WARD: Westbury-on-Trym **CONTACT OFFICER:** Andrew Cross
SITE ADDRESS: Southmead Police Station Southmead Road Bristol BS10 5DW

APPLICATION NO: 15/06605/F Full Planning
EXPIRY DATE: 4 April 2016

Demolition of the existing police station buildings and redevelopment of the site to provide a care home (Use Class C2), associated access, car parking and landscaping and the conversion of an existing building fronting Southmead Road to provide a single dwelling (Use Class C3).

Development Control Committee A – 6 April 2016**Application No. 15/06605/F: Southmead Police Station Southmead Road Bristol BS10 5DW****SITE DESCRIPTION AND APPLICATION**

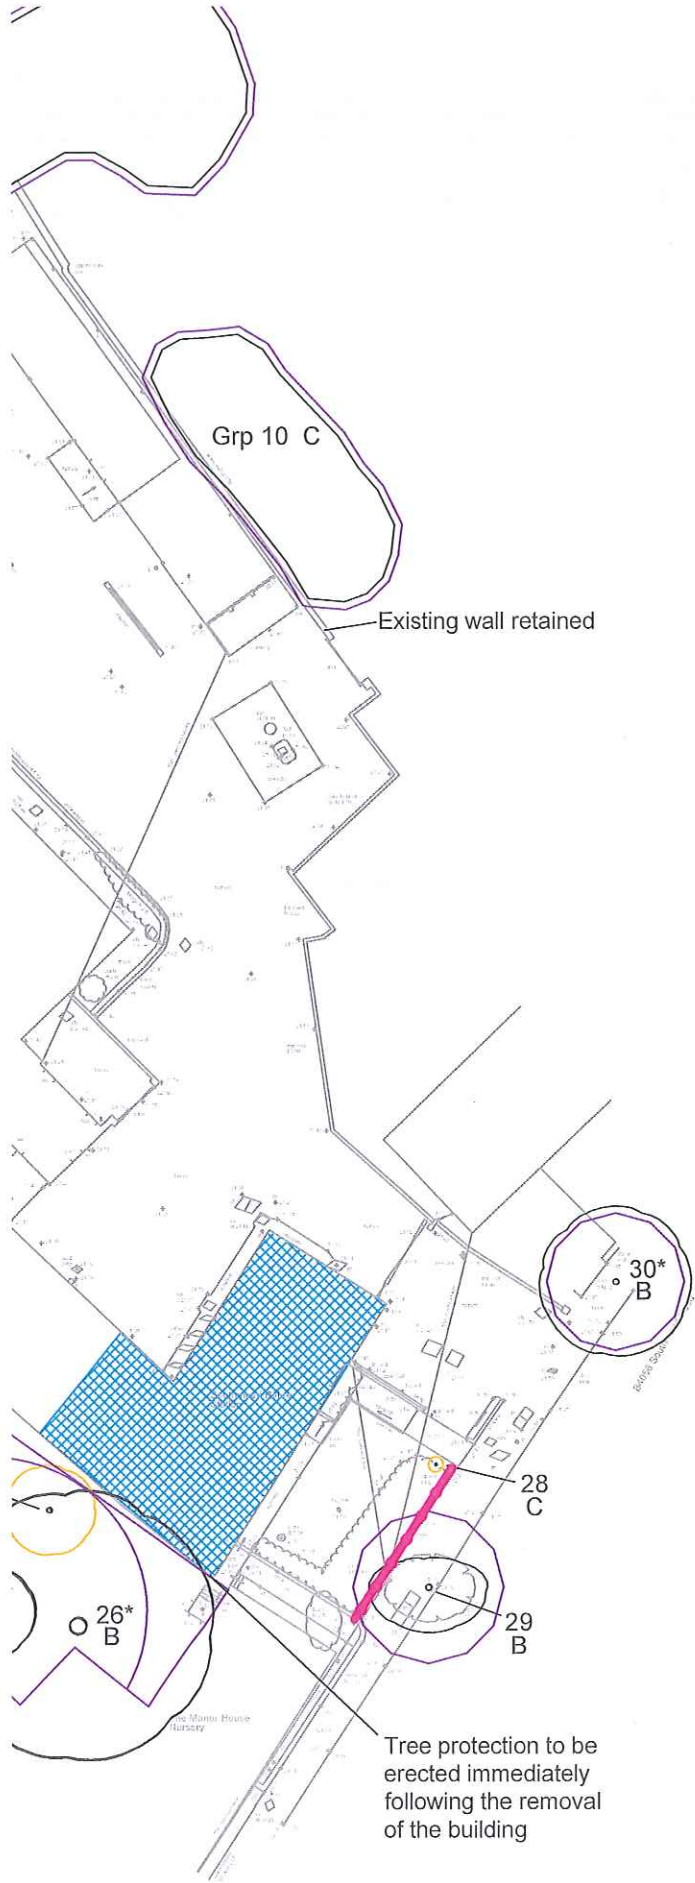
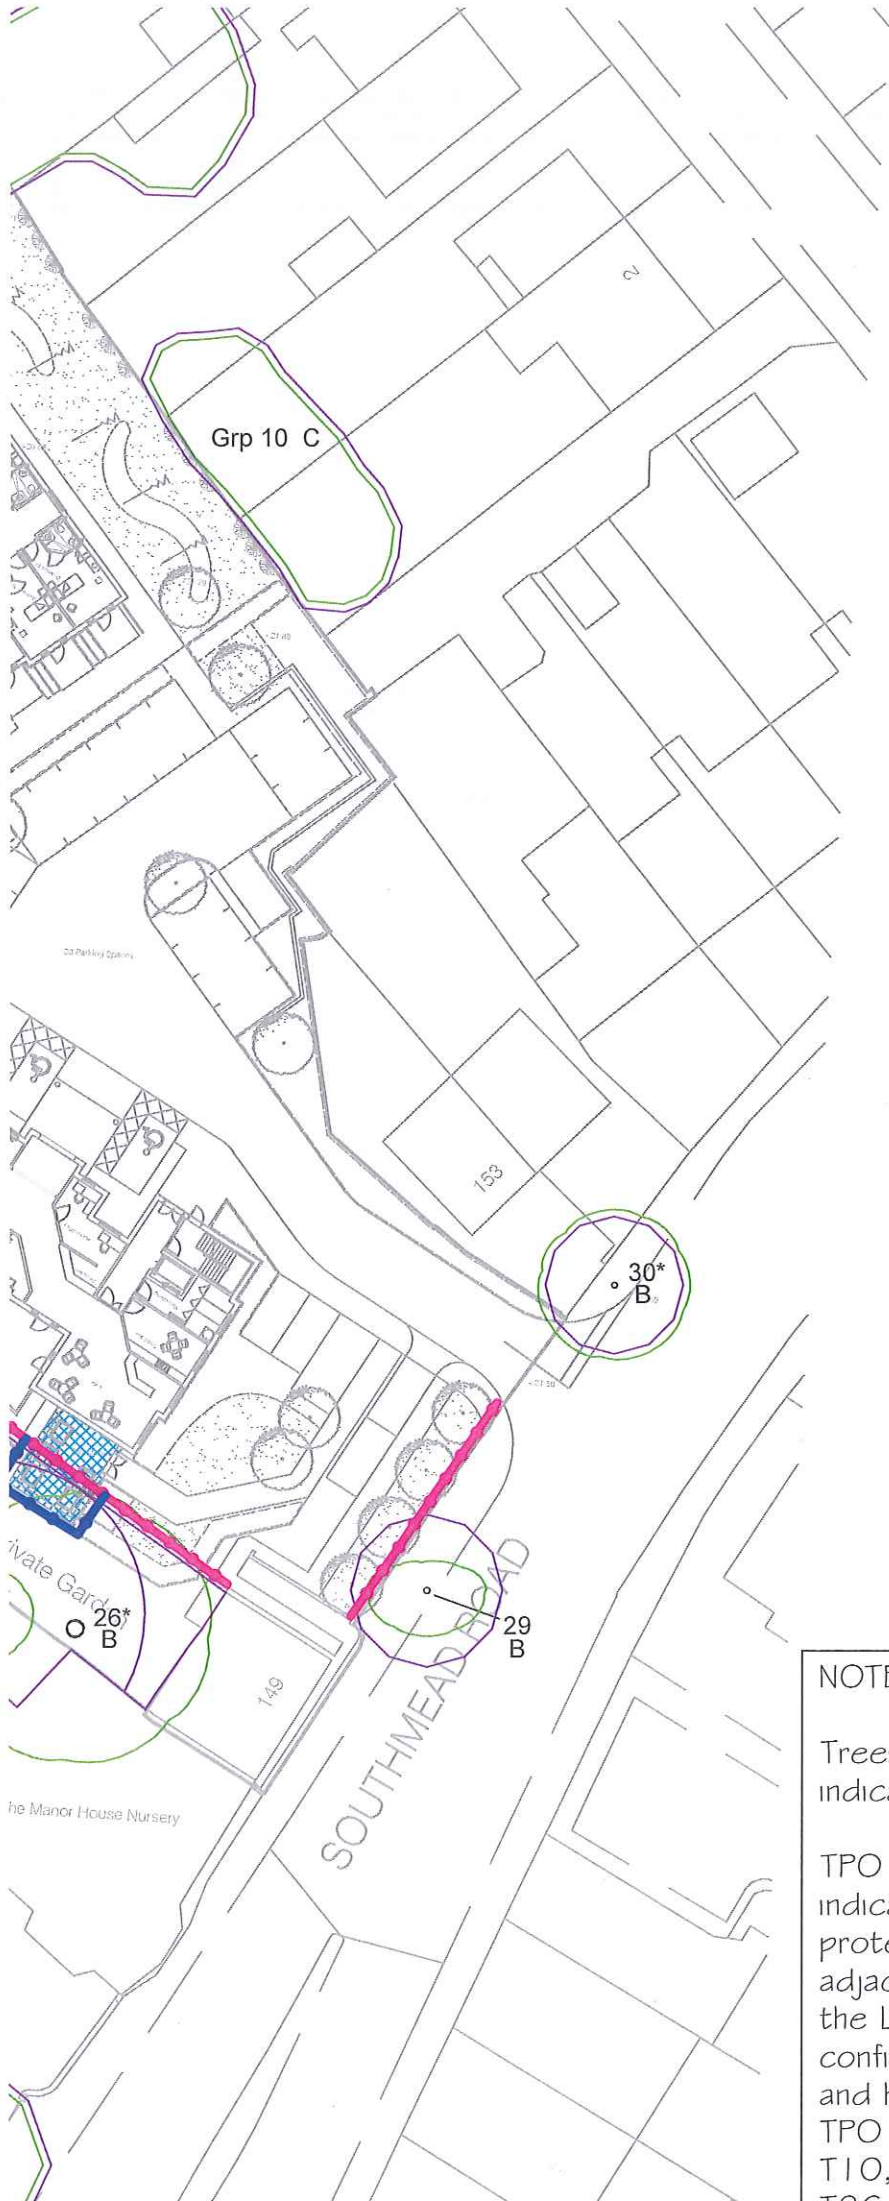
The Tree Protection Plan "CBA10355.03 Construction TPP" appears to show a number of soil level changes adjacent to the North West wall of the proposed development. These soil level changes are within the root protection area of trees 2&4 and have not been defined within the arboricultural method statement.

Prior to the commencement of any development on the site, detailed information shall be submitted to and approved in writing by the Local Planning Authority, regarding any proposed ground/soil level changes within the root protection areas of retained trees on site. Once agreed, the development shall be carried out in accordance with the agreed details.
